**INTEGRATED CIRCUITS, SILICON MONOLITHIC,
BIPOLAR 4-BIT BINARY COUNTER,
BASED ON TYPE 54LS93**

ESA/SCC Detail Specification No. 9204/008

| Issue/Rev. | Date | Approved by | |
|------------|---------------|---|---|
| Issue 4 | February 1994 |  |  |

DOCUMENTATION CHANGE NOTICE

FIGURE 2(a) - FLAT PACKAGE

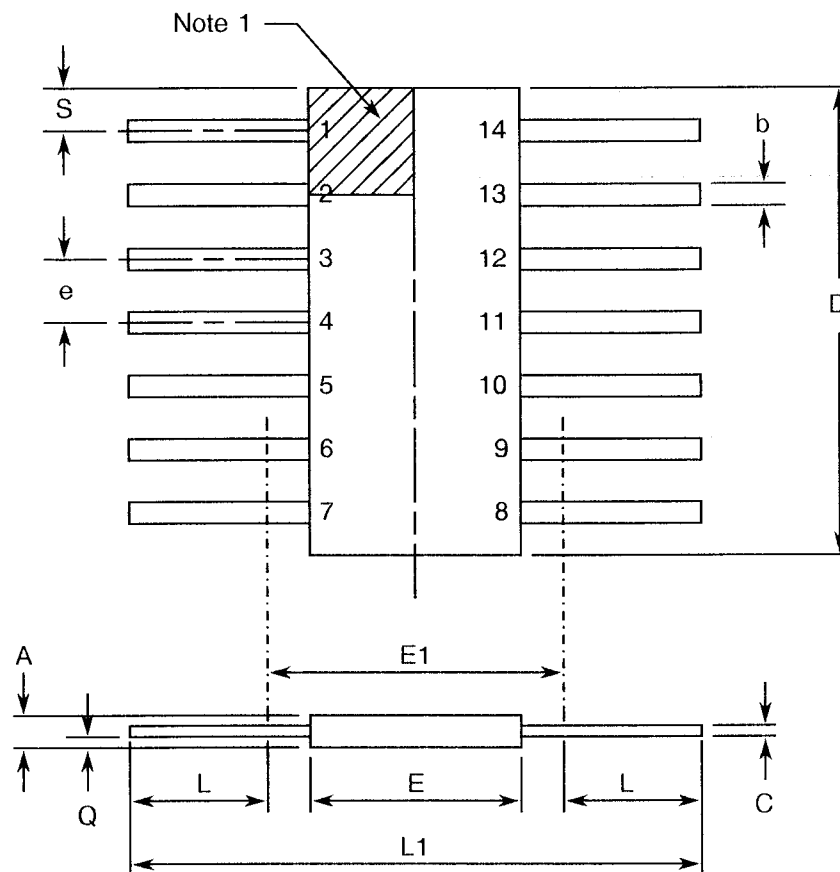
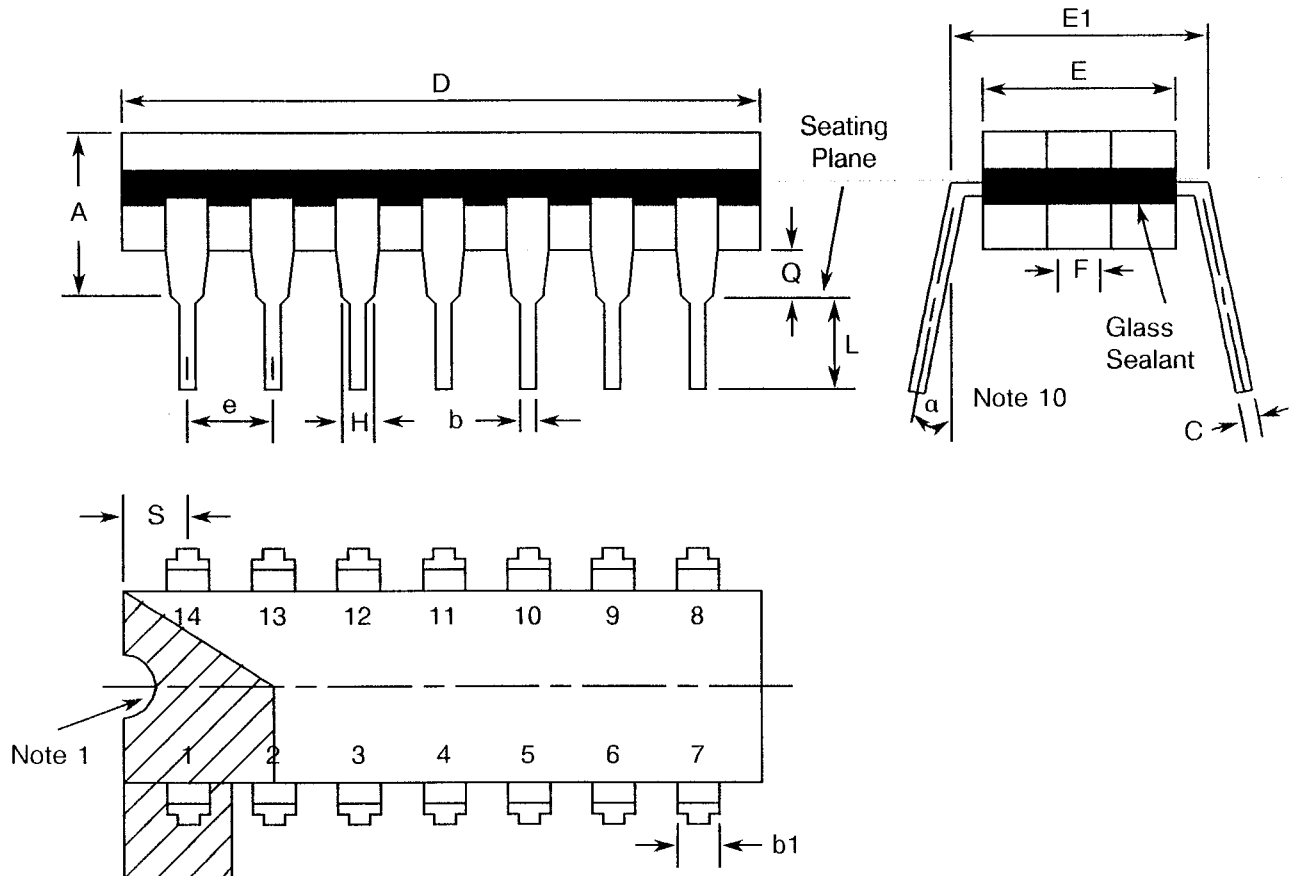
| Rev. Letter | Rev. Date | Reference | CHANGE Item | Approved DCR No. |
|-------------|-----------|--|---|------------------|
| | | Figures 2(a), (b) | : Drawing and Table amended | 221033 |
| | | Figures 2(a), (b), (c) | : Imperial dimensions deleted | 22881 |

FIGURE 2 - PHYSICAL DIMENSIONS (CONTINUED)
FIGURE 2(b) - DUAL-IN-LINE PACKAGE

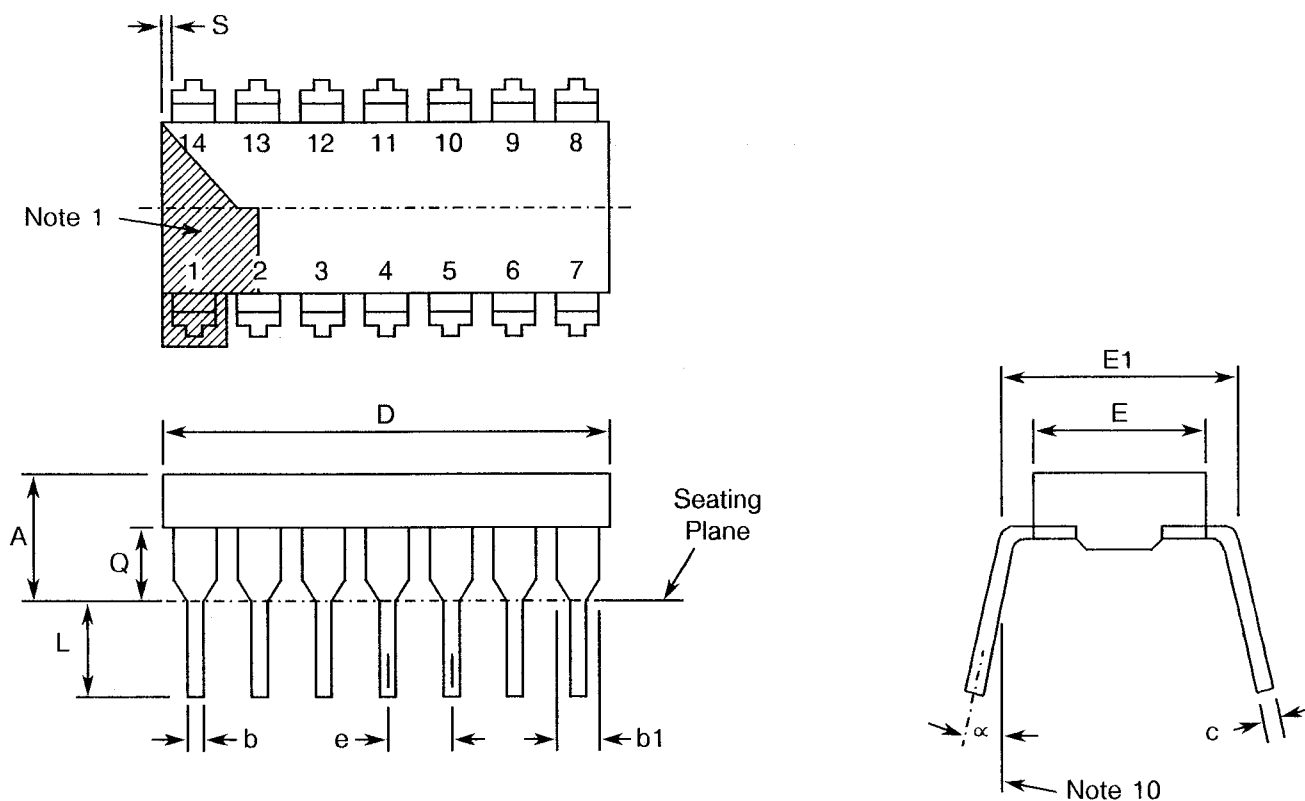
| Rev. Letter | Rev. Date | Reference | CHANGE Item | Approved DCR No. |
|-------------|-----------|--|---|------------------|
| | | Figures 2(b), (c) | : Reference to Note 6 amended to "Note 10" | 23519 |

FIGURE 2(d) - SQUARE CHIP CARRIER PACKAGE (3 LAYER BASE)

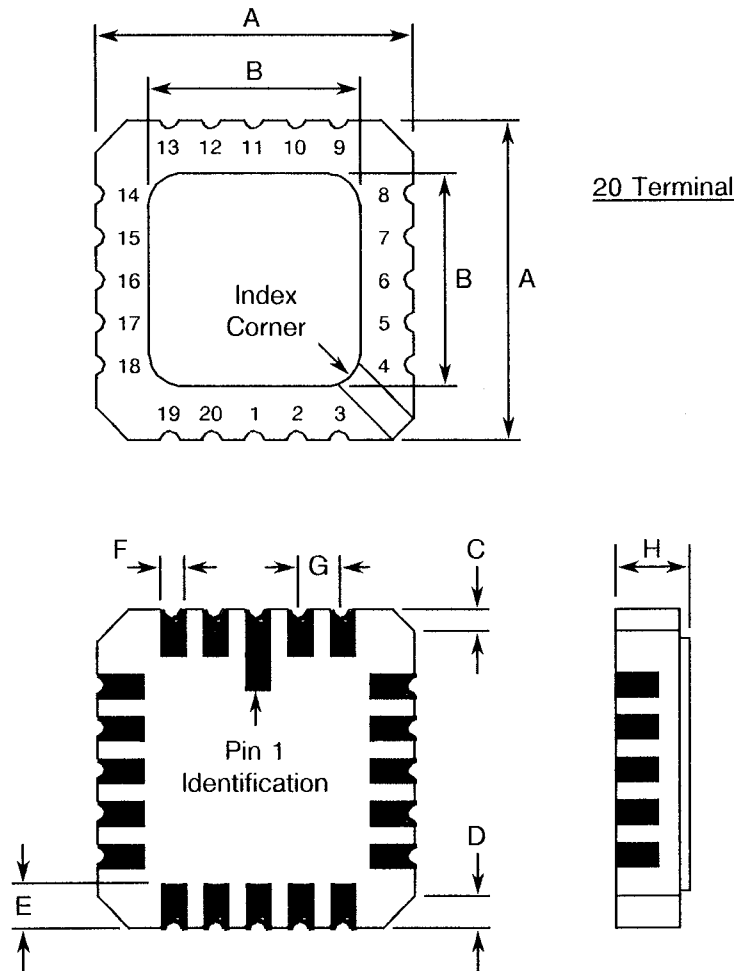
| Rev. Letter | Rev. Date | Reference | CHANGE Item | Approved DCR No. |
|-------------|-----------|--|---|------------------|
| | | Figure 2(d) | : New figure added | 22881 |

FIGURE 3(a) - PIN ASSIGNMENT

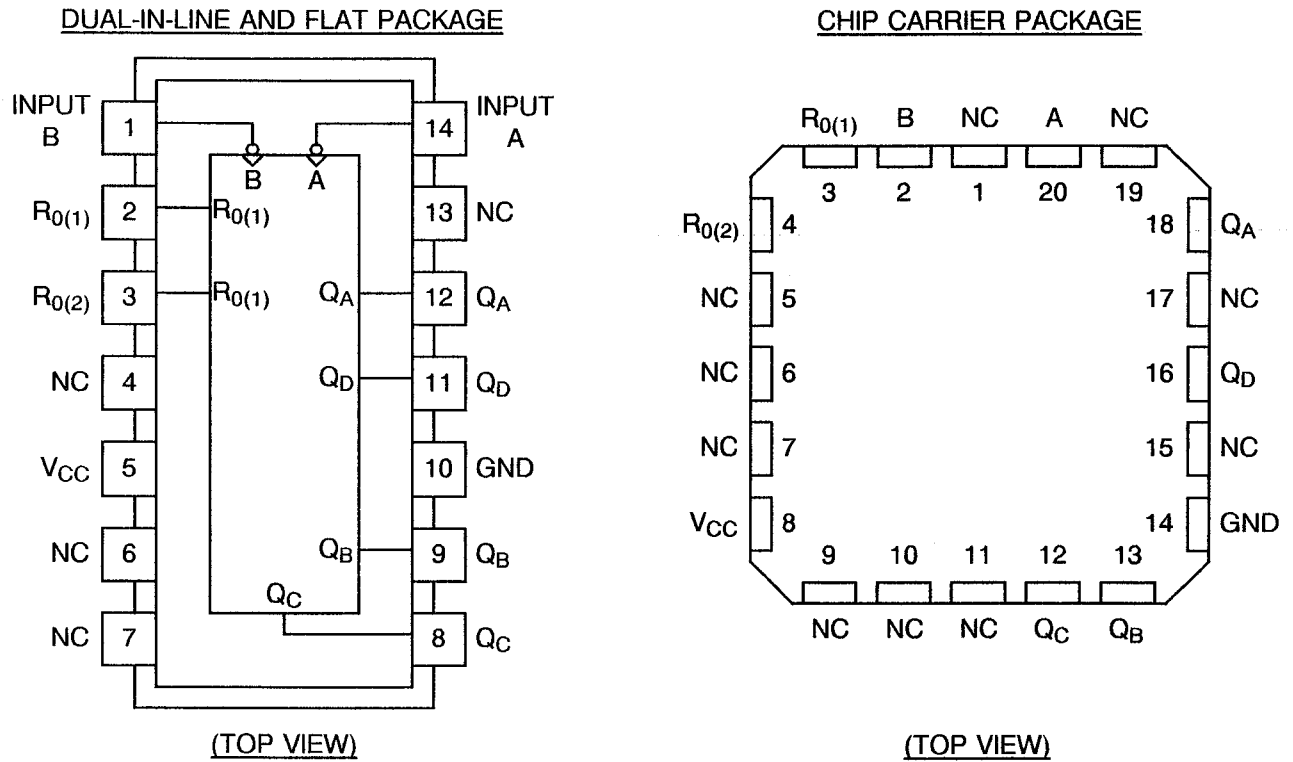
| Rev. Letter | Rev. Date | Reference | CHANGE Item | Approved DCR No. |
|-------------|-----------|--|---|------------------|
| | | Figure 3(a) | : Figure for chip carrier package added | 22881 |
| | | | : Subtitles added above both drawings | 22881 |
| | | | : Comparison table added | 22881 |
| | | | : Note 1 added | 22881 |

FIGURE 4(h) - DYNAMIC TEST AND SWITCHING WAVEFORMS

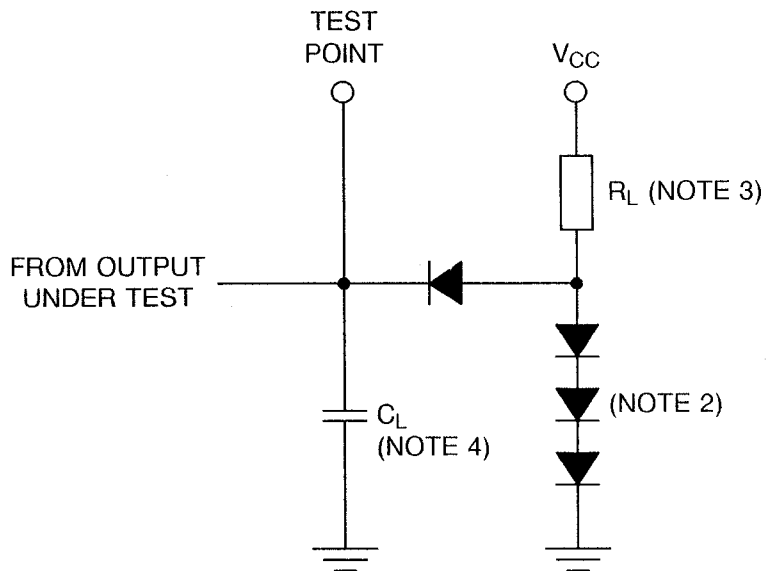
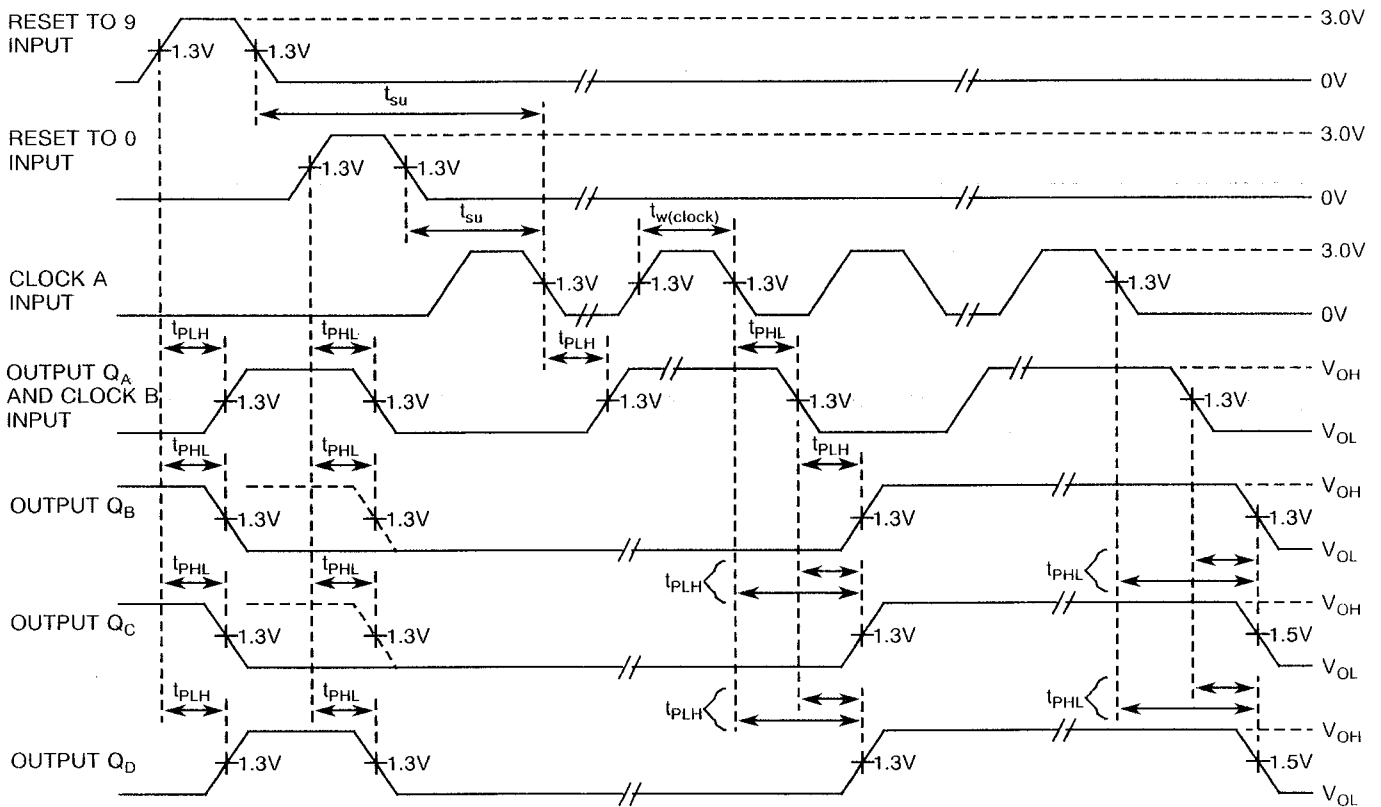
| Rev. Letter | Rev. Date | Reference | CHANGE Item | Approved DCR No. |
|-------------|-----------|--|---|------------------|
| | | Figure 4(h) | : Note added identifying value for R _L | 23642 |

FIGURE 5 - ELECTRICAL CIRCUIT FOR POWER BURN-IN AND OPERATING LIFE TEST

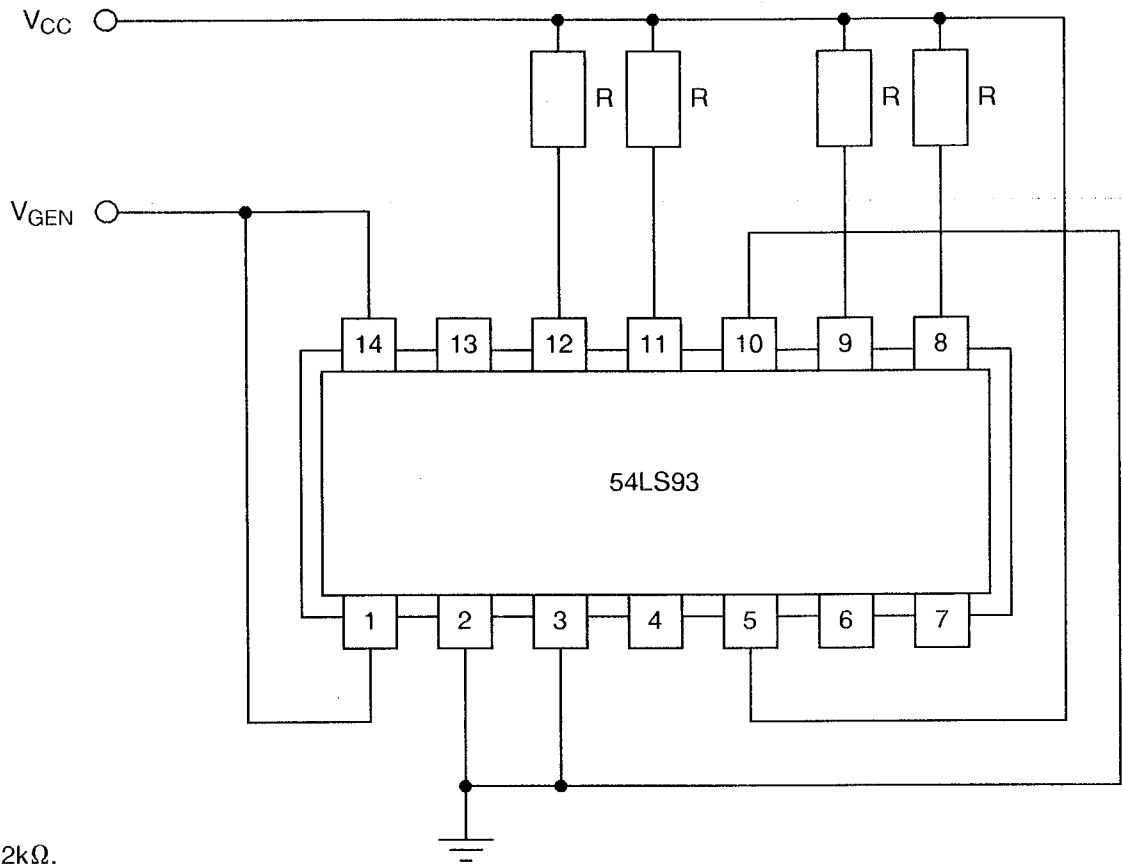
| Rev. Letter | Rev. Date | Reference | CHANGE Item | Approved DCR No. |
|-------------|-----------|--|---|------------------|
| | | Figure 5 | : Diodes removed from Pins 8 and 9, and Ground connection removed from Pins 6 and 7 | 23642 |
